Access Compliance Report Public Rights-of-Way (Curb Ramps)

Main Street: N/A Cross Street: ESPERANZA_RD Location: NW

ADA ID: RPAT210923141557 Ramp Type: Type 7 - Directional 2 Initial Pass/Fail: Fail Overall Compliance: No Severity Score: 16

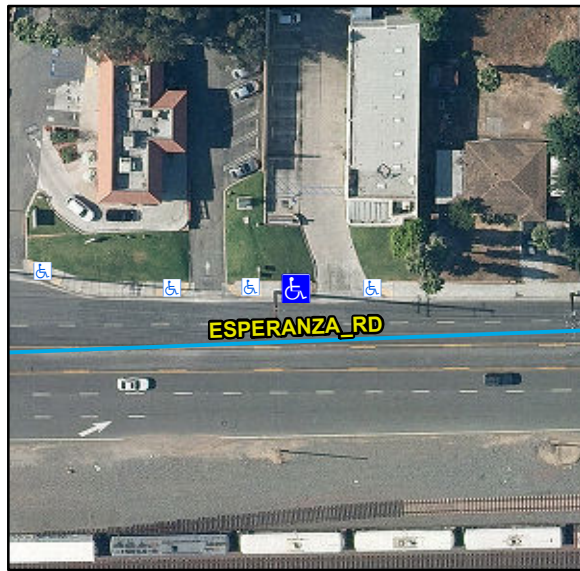
R304.2.2, R304.5.3, STD 1115

Compliance	Description	Data	Compliance	Description	Data
N/A	Ramp Length (in)	58	N/A	Flare Type LT	
Yes	Ramp Width (in)	93			N/A
No	Ramp Run Slope (%)	10.4	N/A	Flare Slope LT (%)	N/A
No	Ramp Cross Slope (%)	3.7	N/A	Flare Traversable LT	N/A
N/A	Grade Break	N/A	N/A	Flare Type RT	
N/A	Grade Break Slope (%)	N/A			N/A
N/A	Grade Break Cross Slope (%)	N/A	N/A	Flare Slope RT (%)	N/A
	Addl Para Ramp Left?	N/A	N/A	Flare Traversable RT	N/A
	Addl Para Ramp Right?	N/A	N/A	DWS Provided	N/A
N/A	Landing Present	N/A	N/A	DWS Contrast	N/A
N/A	Landing Length (in)	N/A	N/A	DWS Length (in)	N/A
N/A	Landing Width (in)	N/A	N/A	DWS Full Width	N/A
N/A	Landing Run Slope (%)	N/A		DWS Offset Type	N/A
N/A	Landing Cross Slope (%)	N/A	N/A	DWS Left Offset (in)	N/A
N/A	Landing Movement Obstructed?	N/A	N/A	DWS Right Offset (in)	N/A
	Landing Movement Type	N/A			
N/A	Landing Shared	N/A			
N/A	Marked Crosswalk 1	No	N/A	Clear Space	N/A
	Crossing 1 Direction	E	N/A	Clear Space To Crosswalk (in)	N/A

Remove & Replace Entire Ramp.
